28 September 2023

Megan Barr
Consultant Resource Consents Planner
Kapiti Coast District Council

RM230036- Response to Section 92 Request for 126-130 Rosetta Road

PROJECT STATUS		RESOURCE CONSENT	
SCALE	AS INDICATED	DATE	21/09/2023
DESIGN	-	DRAWN	MD
PROJECT NO.	22-006	SHEET NO.	A410
		REV	3

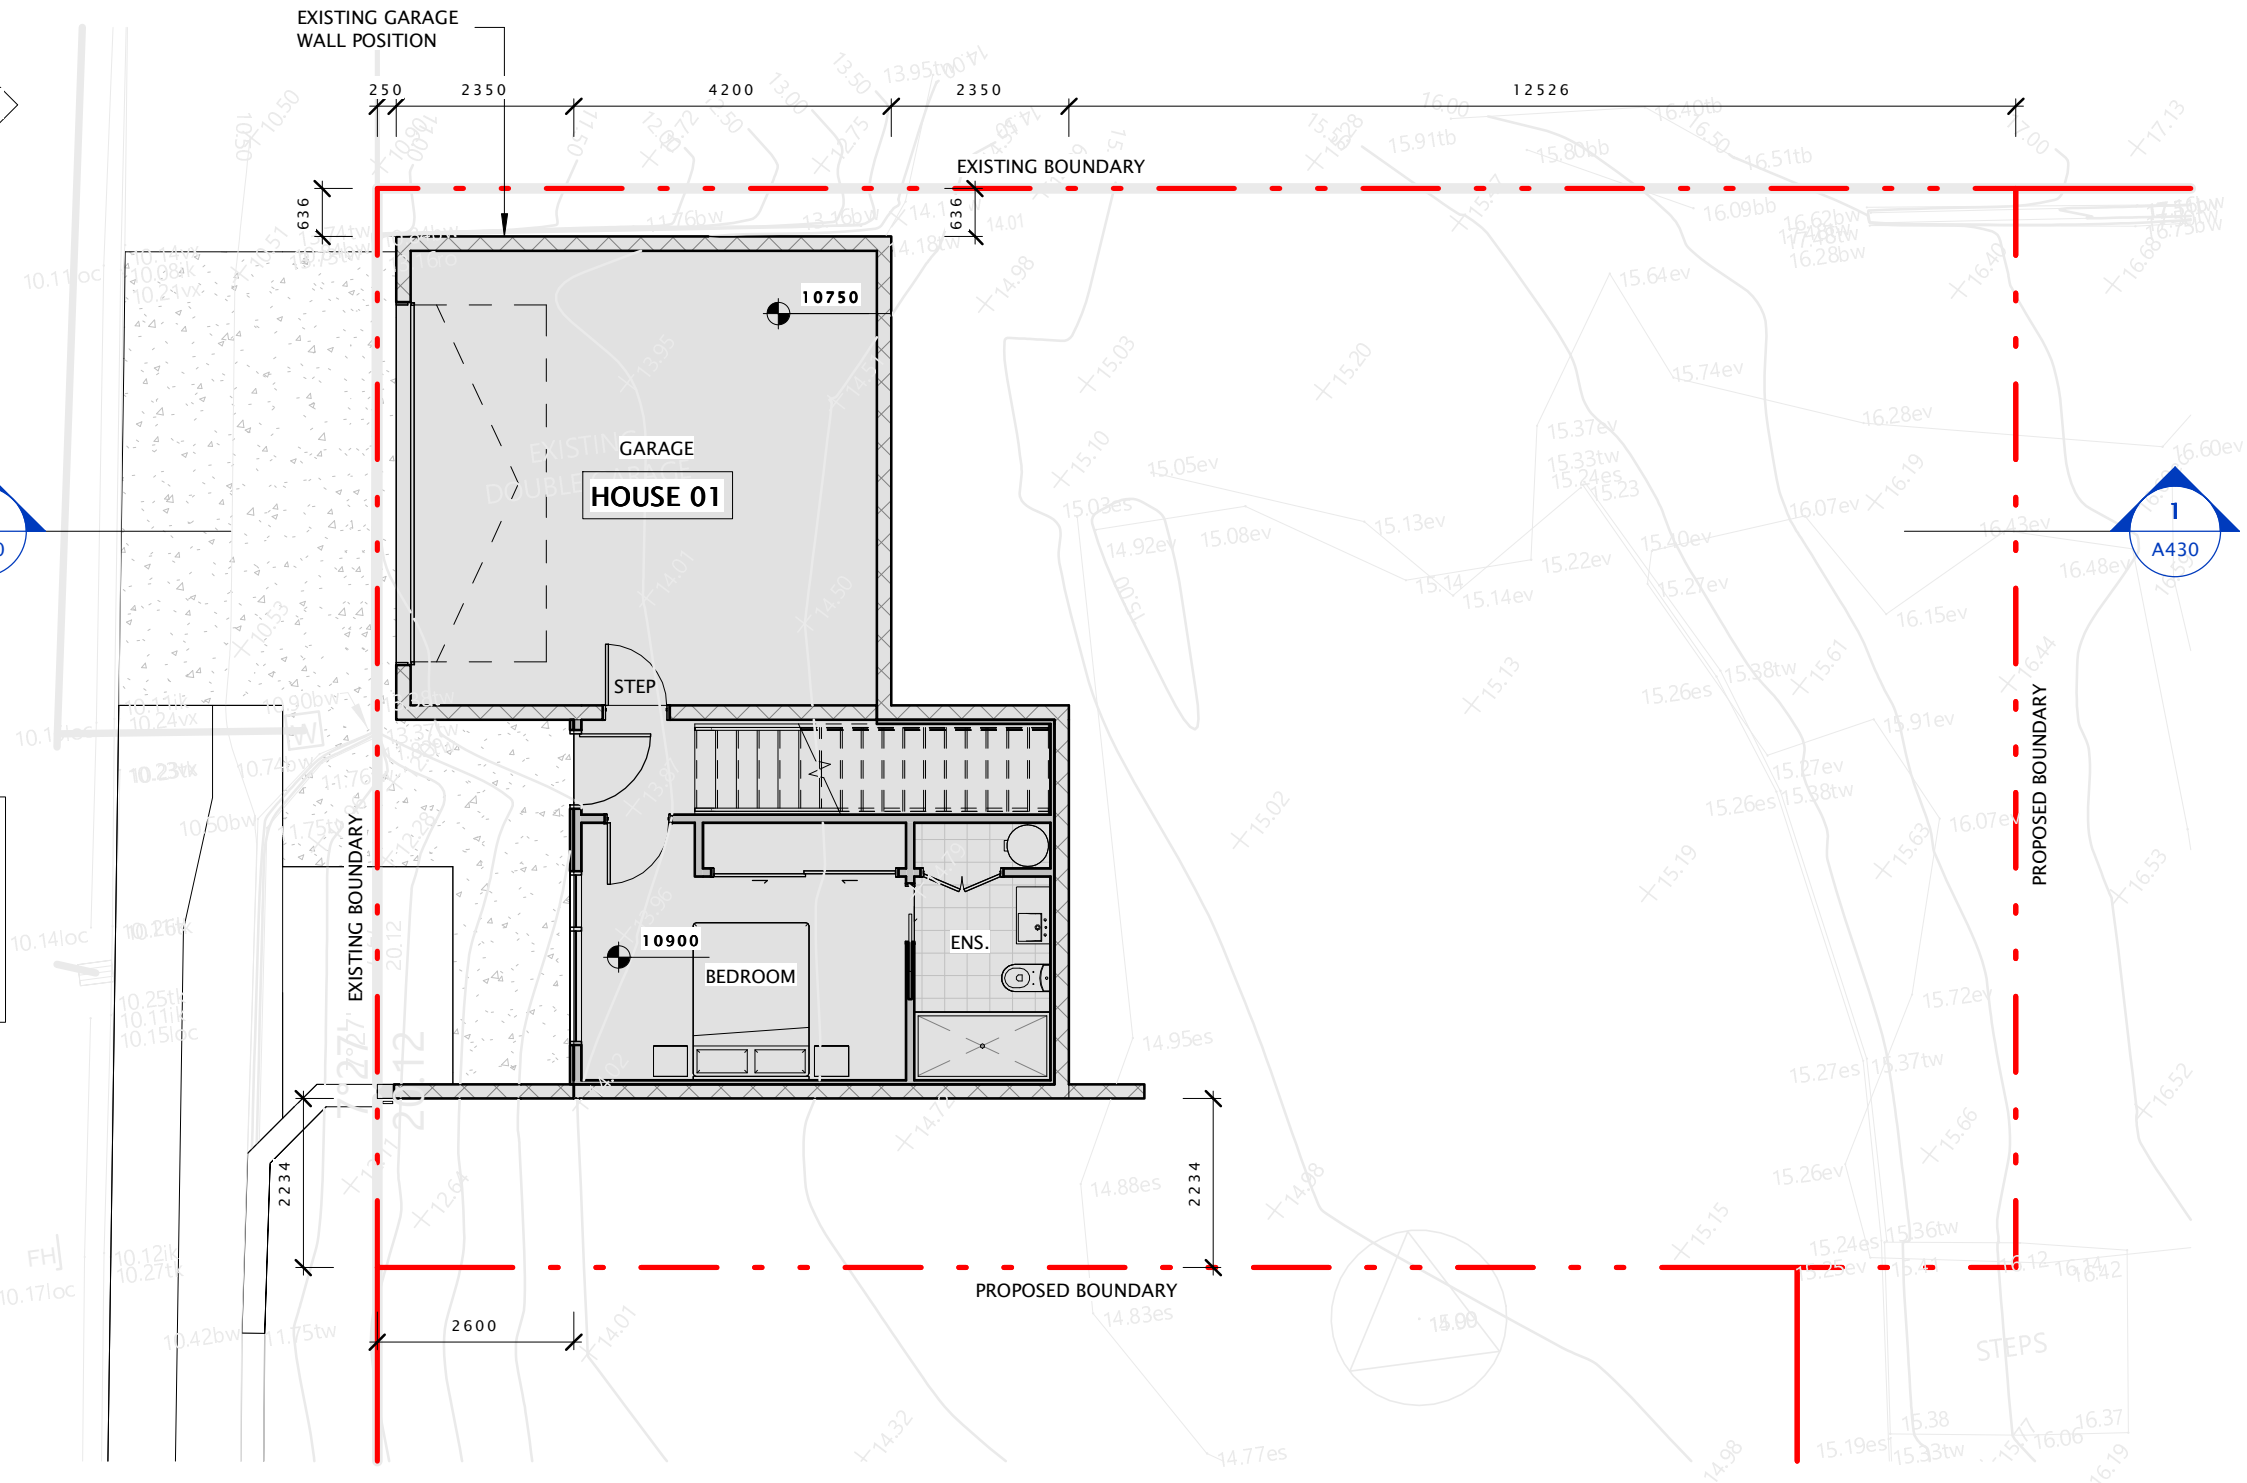
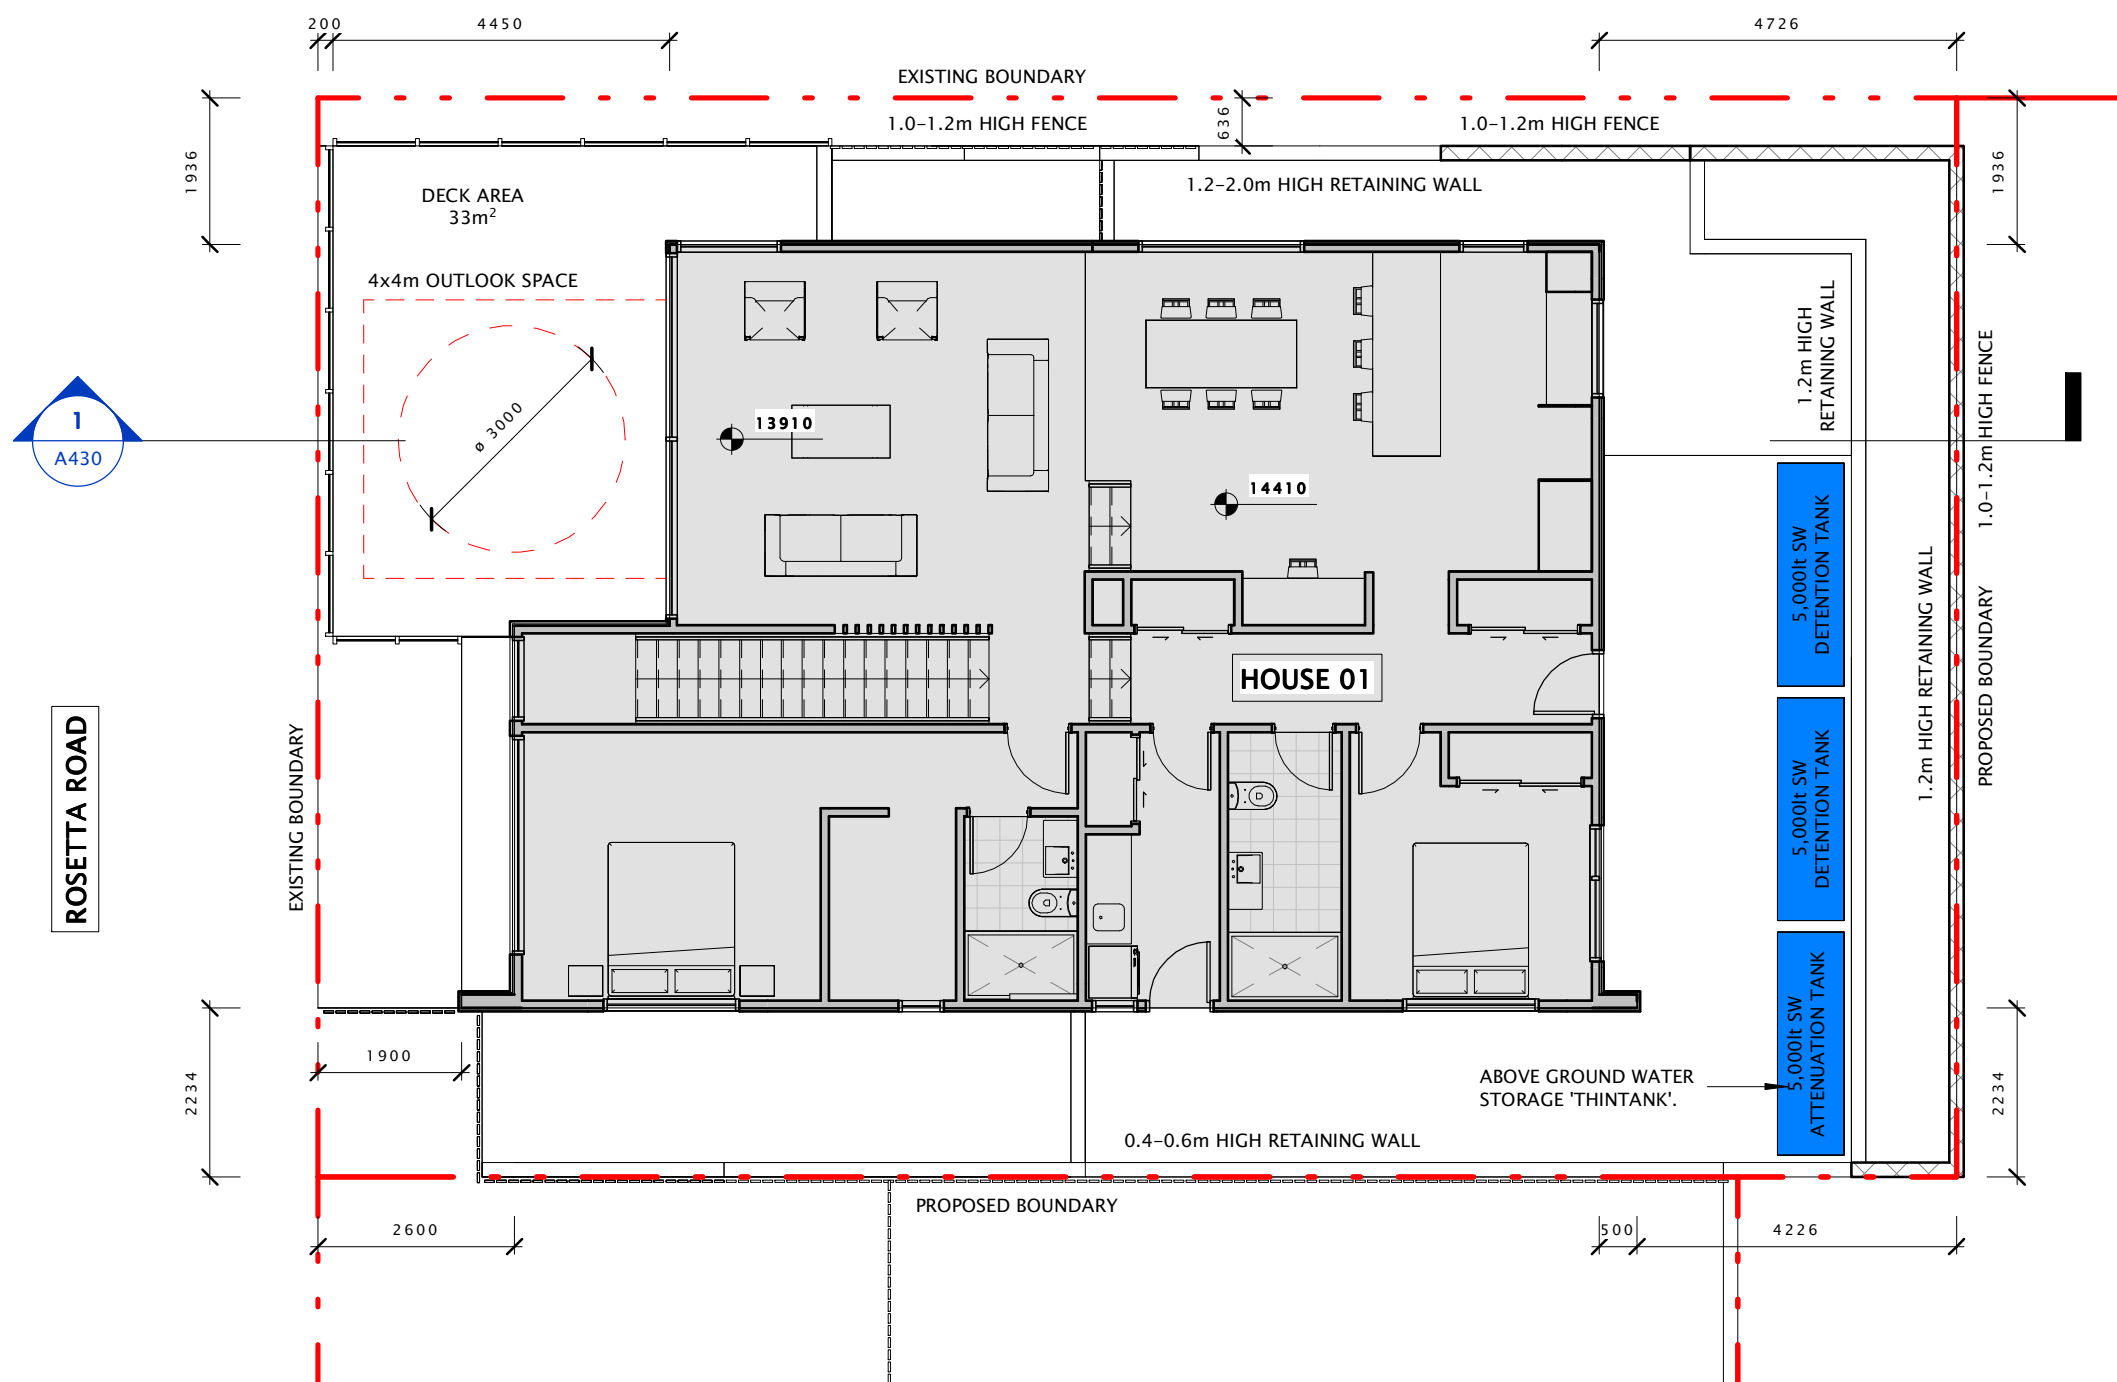
Drawing Sheets A410 Rev 2 and A430 Rev 2 are shown below for the House 1 garage, with scaled internal dimensions 6.1 m wide by 6.25 m deep, the proposed garage door is 2.1 m high and 4.7 m wide (offset 0.7 m each side). No laundry is shown within the garage but is instead upstairs. The garage floor level is shown as 10.900 with the kerb scaled as RL 10.30 offset by 3.8 m. This would indicate an average gradient of 15.8% although the section A-A shows an initial gradient of 12.5% (1 in 8, 0.4/3.2) and then a short steeper grade (1 in 3, 0.2/0.6).
